Appendix L: Tab 3

**Re: 2nd Review of Full EAF Part 1 and Exhibits for District East
OCIDA Environmental and Engineering Services Support
JMT Job #22-02972-001**

RE: DISTRICT EAST DEVELOPMENT
JANUARY 2023 TRAFFIC IMPACT STUDY
TOWN OF DEWITT, ONONDAGA COUNTY

**Re: Response to JMT 1-31-2023 2nd Review Traffic Study Comments – District East Development
Former Shoppingtown Mall – Town of DeWitt, NY**

Sheet Number:	S-1
Sheet Name:	SITE PLAN
Scale:	N.T.S.
Date:	JANUARY 17, 2022

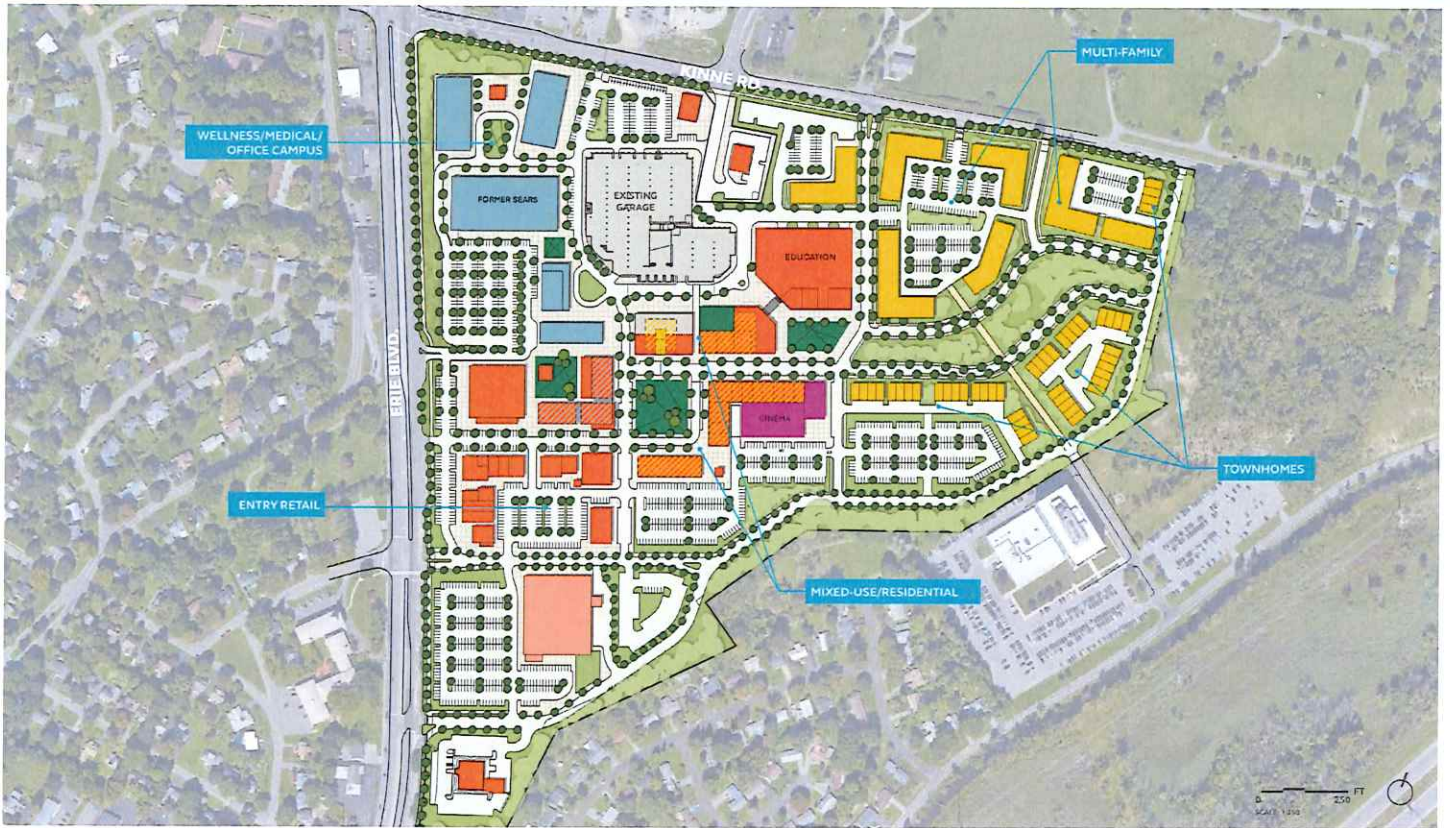
4. The conceptual plan shows two new access points on Erie Blvd; only the one new right-in right-out is mentioned in the scope. In general, the Department is not in favor of additional access to Erie Blvd; it creates additional conflict points for both vehicles and pedestrians. The TIS should show why this access is beneficial to the State's road network/intersections.
